**1.0 APPLICATION SUMMARY**

Applicant: Belleair Development, LLC  
 FLU Category: CPV  
 Service Area: Urban  
 Site Acreage: 11.3  
 Community Plan Area: Citrus Park  
 Overlay: None  
 Request: Add vehicular connections

**AGENCY REVIEW COMMENT SHEET**

PETITION NO: PRS 21-1037

2.3 Proposed Site Plan – General Site Plan – (partial provided below for size and orientation purposes. See Section 8.2 for full site plan)

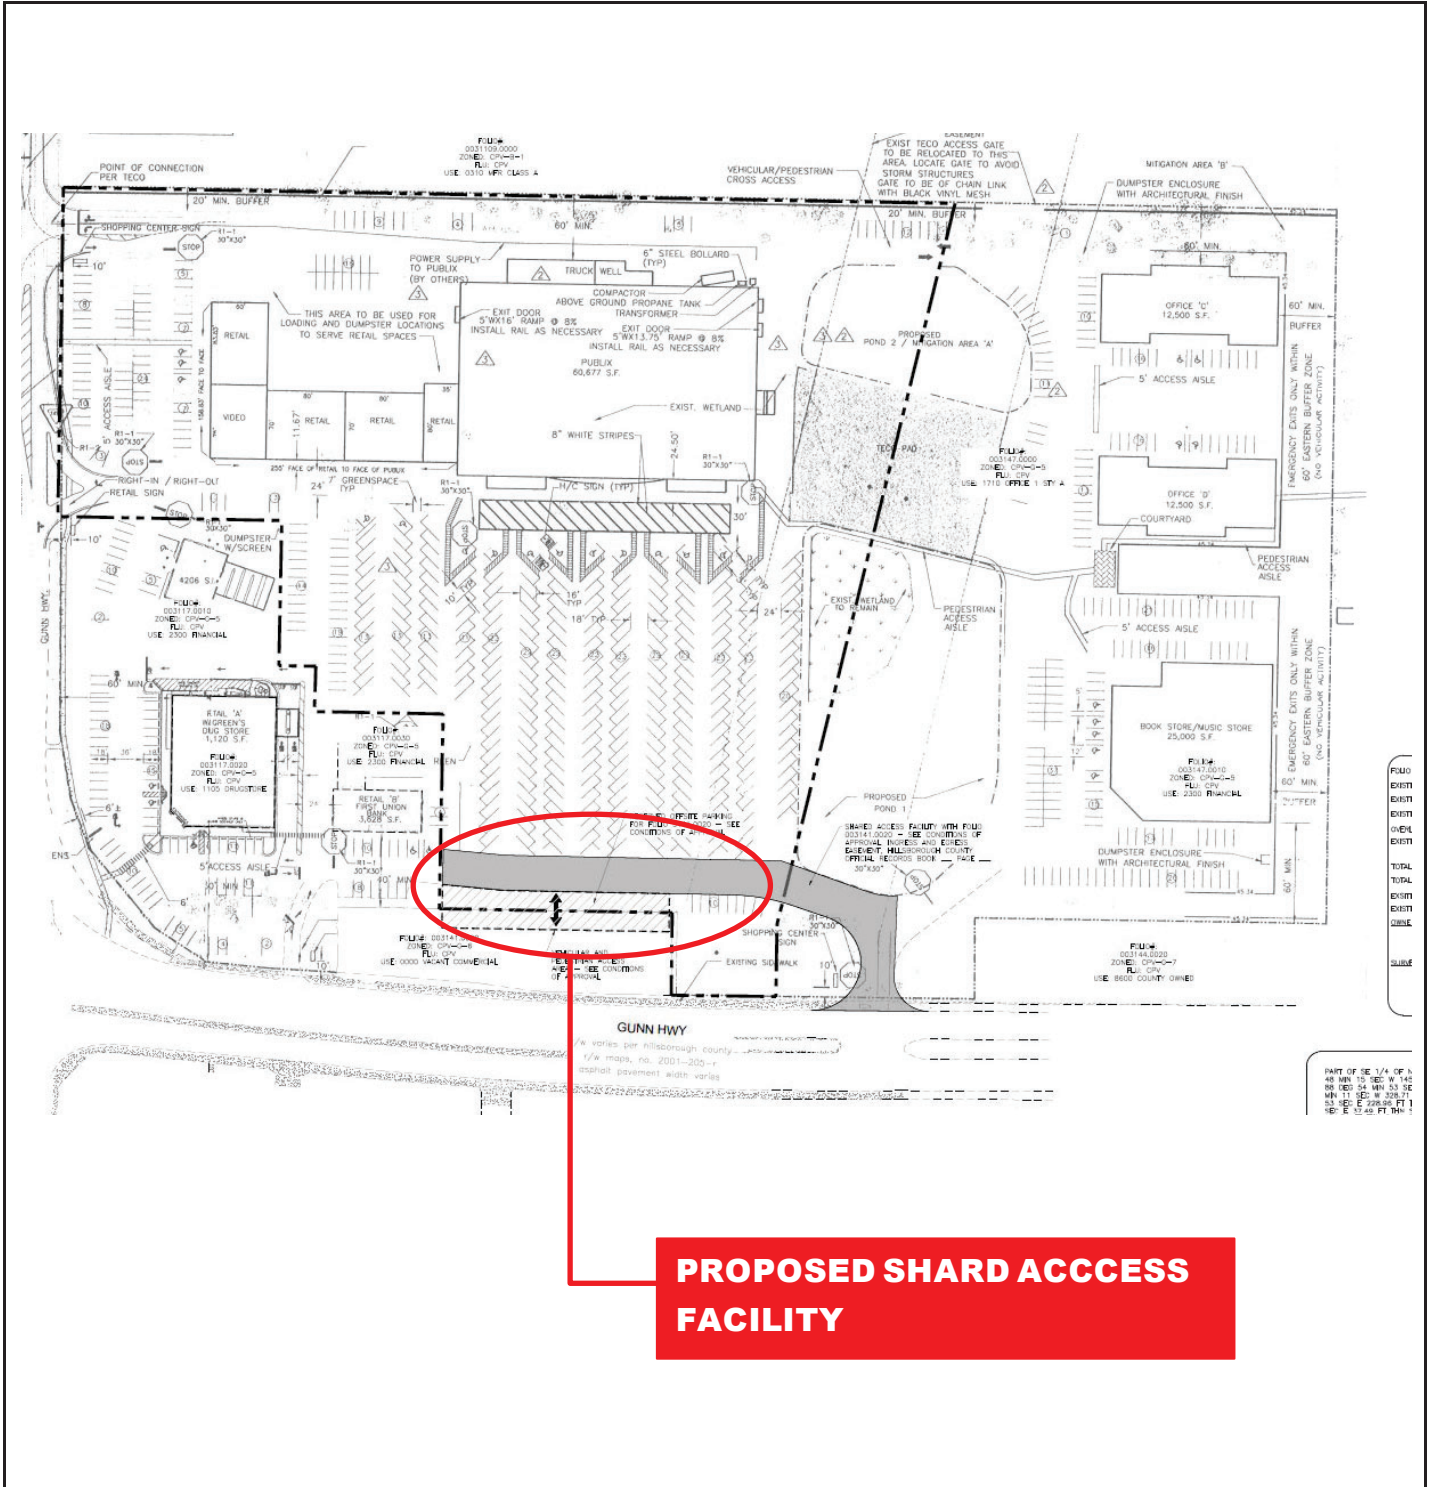
Staff notes that the revised PD plan is drawn incorrectly, as it does not show the area between the shaded Shared Access Facility (SAF) and folio 3141.0020 within the SAF, despite there being one or more planned driveways and drive aisles within this area which are an integral part of the SAF. In order to allow this project to move forward, staff has addressed this discrepancy within the PD zoning conditions.

- Notwithstanding anything on the PD Site Plan to the contrary, internal project driveways and drive aisles labeled as Shared Access Facilities, together with driveways and drive aisles within the area designated on the PD Site Plan as Offsite Parking for Folio 3141.0020, shall be considered a Shared Access Facility with folio 3141.0020 (and such facilities shall treated as the sole legal means of vehicular access to the adjacent folio).

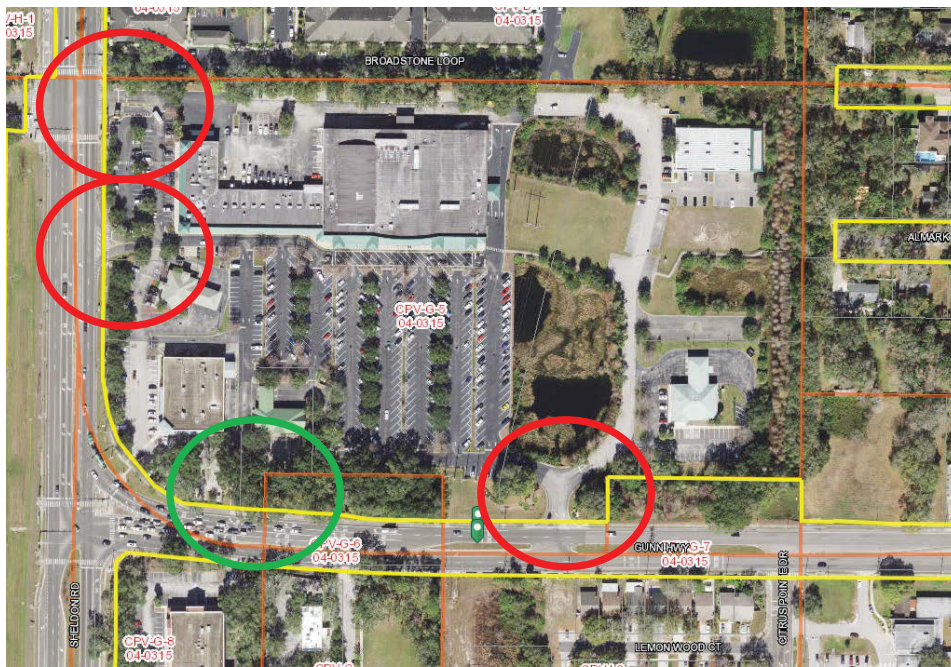
The above described changes to the subject PD (including the designation of internal driveways and drive aisles as a Shared Access Facility, which allows the Adjacent Proposed PD to take its sole legal means of access through the subject project) are being done in order to facilitate development of the Adjacent Proposed PD which would otherwise not be supported by the County, as its access to Gun Highway would not meet minimum spacing requirements (and although each parcel is entitled to access, it is not entitled to intensify use of the property, as is currently being proposed via a separate zoning action (without meeting appropriate access management standards or otherwise obtaining the appropriate Section 6.04.02.B. Administrative Variances and/or Design Exceptions).

Furthermore, the size and configuration of the Adjacent Proposed PD would make it impossible to develop the Adjacent Proposed PD with their intended use (a car wash) at the proposed intensity and in the proposed configuration, given the minimum parking required which cannot be fit on the site, and based on other factors. Given the above, these shared access facilities and reserved parking areas will be critical to the functioning of the Adjacent Proposed PD and are necessary in order allow consideration of the proposed zoning of that parcel.

Staff has seen preliminary transportation analyses prepared in support of the Adjacent Proposed PD (and are not a part of this zoning record), which studied the access points that are anticipated to serve that project (i.e. the access points within the PD). Notwithstanding the designation of certain drive aisles between the Adjacent Proposed PD and one project access, which is the minimum necessary to facilitate a legal means of access to the Adjacent Proposed PD through this PD (i.e. the SAF), there are additional access points within the subject PD which are anticipated to serve the proposed project. The access connections anticipated to serve as primary access for the Adjacent Proposed PD are shown in red below (i.e. one access connection east of the site, and two connections northwest of the site). Other anticipated secondary access is shown as a green circle.

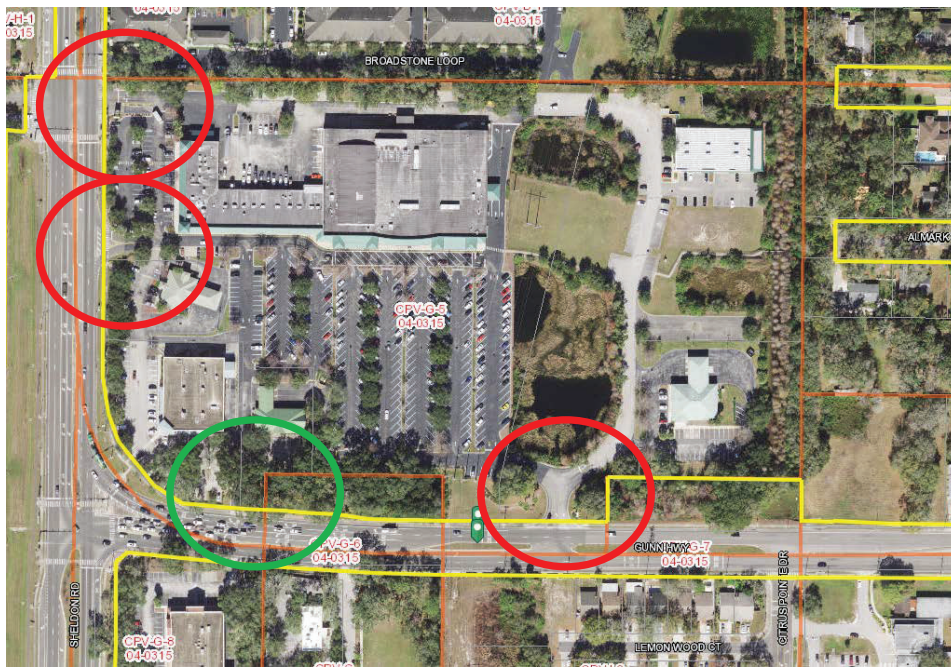
Furthermore, the size and configuration of the Adjacent Proposed PD would make it impossible to develop the Adjacent Proposed PD with their intended use (a car wash) at the proposed intensity and in the proposed configuration, given the minimum parking required which cannot be fit on the site, and based on other factors. Given the above, these shared access facilities and reserved parking areas will be critical to the functioning of the Adjacent Proposed PD and are necessary in order allow consideration of the proposed zoning of that parcel.

Staff has seen preliminary transportation analyses prepared in support of the Adjacent Proposed PD (and are not a part of this zoning record), which studied the access points that are anticipated to serve that project (i.e. the access points within the PD). Notwithstanding the designation of certain drive aisles between the Adjacent Proposed PD and one project access, which is the minimum necessary to facilitate a legal means of access to the Adjacent Proposed PD through this PD (i.e. the SAF), there are additional access points within the subject PD which are anticipated to serve the proposed project. The access connections anticipated to serve as primary access for the Adjacent Proposed PD are shown in red below (i.e. one access connection east of the site, and two connections northwest of the site). Other anticipated secondary access is shown as a green circle.
